SARGENT & LUNDY REPORT

PROJECT 6101-32

LACBWR

INFORMATION ON STRUCTURAL TOPICS

Reactor Containment Vessel
 Critical Stresses
 LACBWR

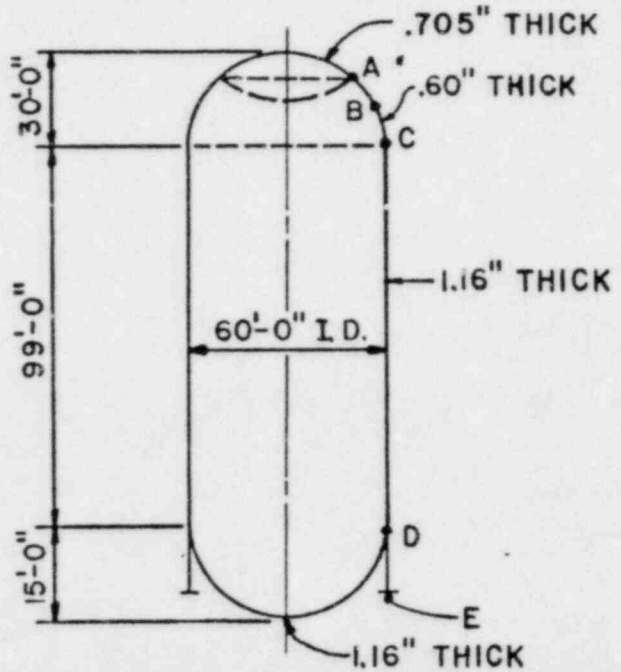
QUESTION 6: Provide the summary of stresses and strains at critical locations in all safety related structures for each load and load combination considered in the design.

The allowable and actual stresses in the vessel at various critical points have been extracted from CB&I design calculations and summarized in the attached Table A 1.

Critical Point (See Sketch Below)	Load/Load Combination	Circumferential Stress PSI		Tangential Stress Compression PSI		Axial Stress Compression PSI	
		Actual	Allowable	Actual	Allowable	Actual	Allowable
A	D	5,886	15,000 C				
	D+L+H+Pe			880	1,762		
B	D+L+H+Pe			805	1,500		
	D+L+H+Pe+Pi	16,280	16,500 T				
C	D+L+H+Pe					550	1,500
	D+L+H+Pe+Pi	16,000	16,500 T				
D	D+L+H+W+E+Pe					1,617	6,730
	D+L+H+W+E+Pe+Pi	8,524	16,500 T				
E	D+L+H+W+Pe+Pi					15,280	16,350
